**RE: 2101 Carlisle Blvd NE  
Conceptual Grading & Drainage Plan  
Engineer's Stamp Date: 1/28/2025  
Hydrology File: H16D047  
Case # HYDR-2025-00008**

CARLISLE & I-40  
CONCEPTUAL GRADING & DRAINAGE PLAN  
2103 CARLISLE BLVD NE  
CITY OF ALBUQUERQUE, COUNTY OF BERNALILLO, STATE OF NEW MEXICO

CONCEPTUAL GRADING &  
DRAINAGE PLAN

DR-1

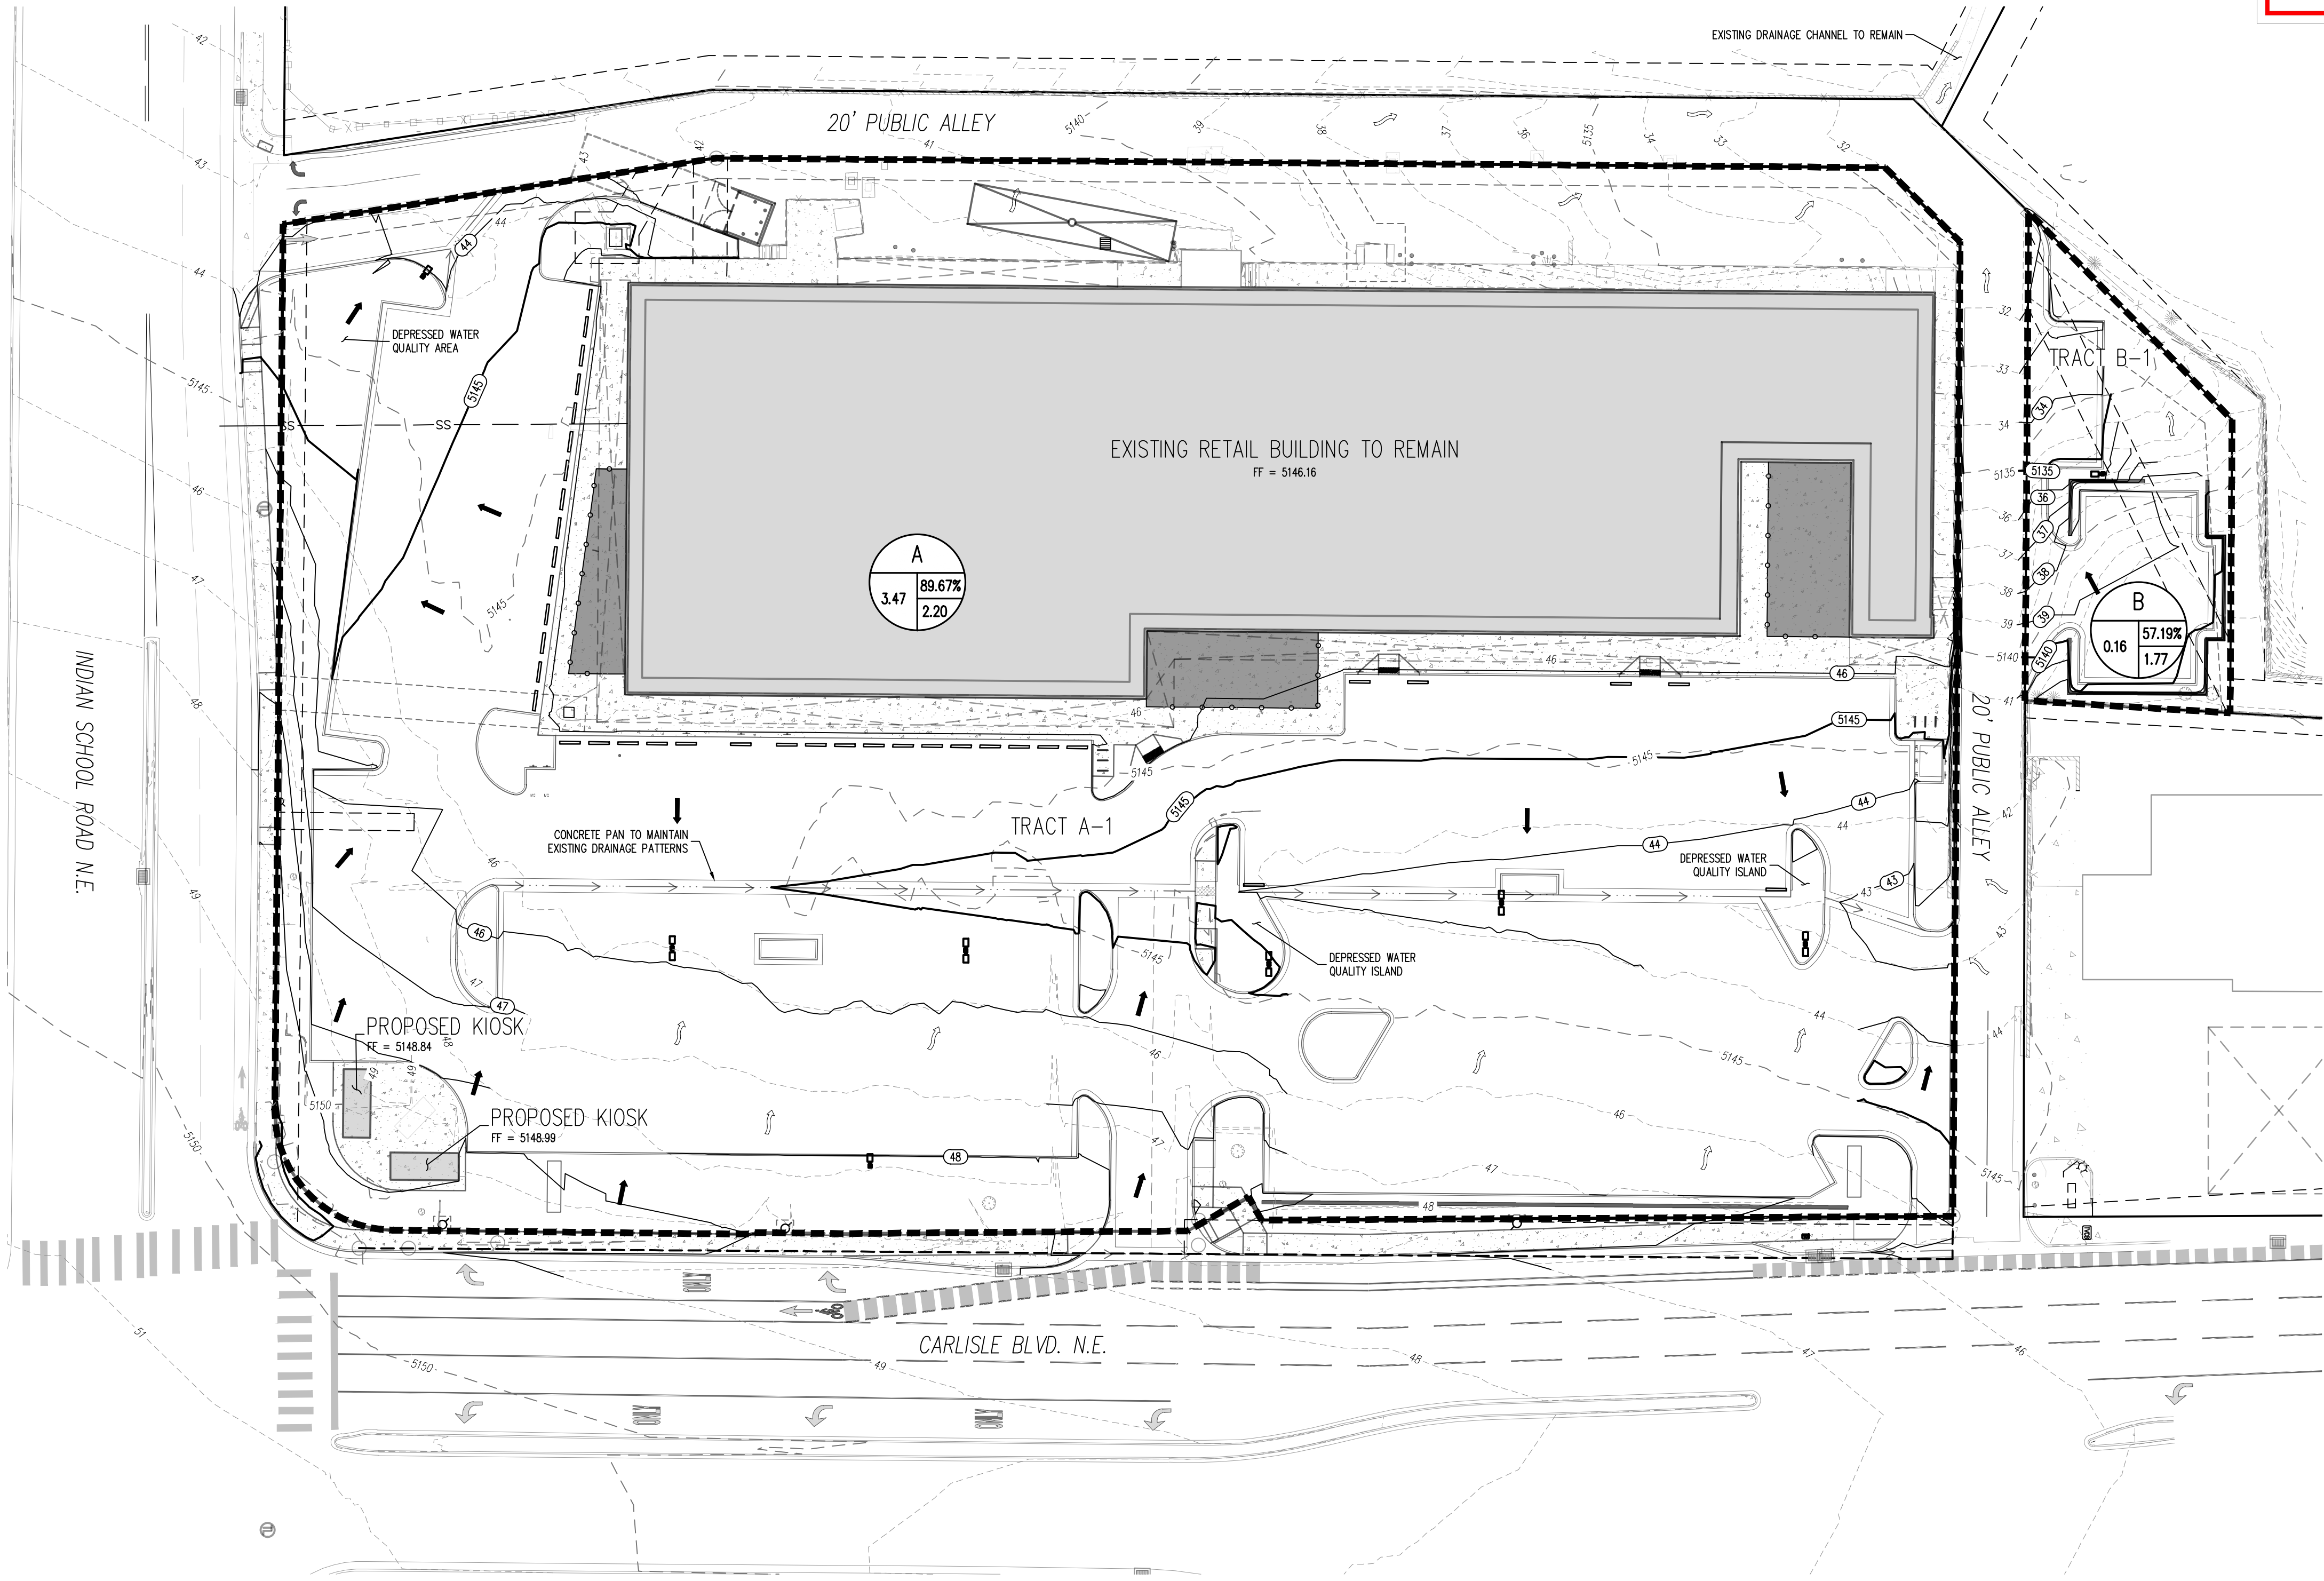
1. Please submit a more detailed Grading & Drainage Plan to Hydrology for review and approval.
2. If requesting a Waiver of Management Onsite, the following conditions of the new drainage ordinance (enacted 10/2/18) must be demonstrated on the plan (§ 14-5-2-6 (H)):

Show where stormwater quality can be effectively controlled through private offsite mitigation, or through an arrangement to utilize a cooperator's existing regional stormwater management infrastructure or facilities that are available to control stormwater quality.

And where one (or more) of the following is met:

- the lot is too small to accommodate management on site while also accommodating the full plan of development;
- the soil is not stable;
- the site use is inconsistent with the capture and reuse of stormwater;
- other physical conditions exist where compliance with on-site stormwater quality control requirement leaves insufficient area;
- public or private off-site facilities provide an opportunity to effectively accomplish the mitigation requirements of this ordinance;

- there is an opportunity to develop a project to replenish regional ground water supplies at an offsite location; or
  - a waiver to state water law or acquisition of water rights would be required in order to implement management on site.
3. If requesting a Waiver of Management Onsite, please add a note which states, "The Owner has elected to pay the Payment in Lieu for the required Stormwater Quality Volume."
  4. If requesting a Waiver of Management Onsite, please show the Payment calculation on the plan. (Payment in Lieu = 3,428cf x \$8/cf = \$27,424).
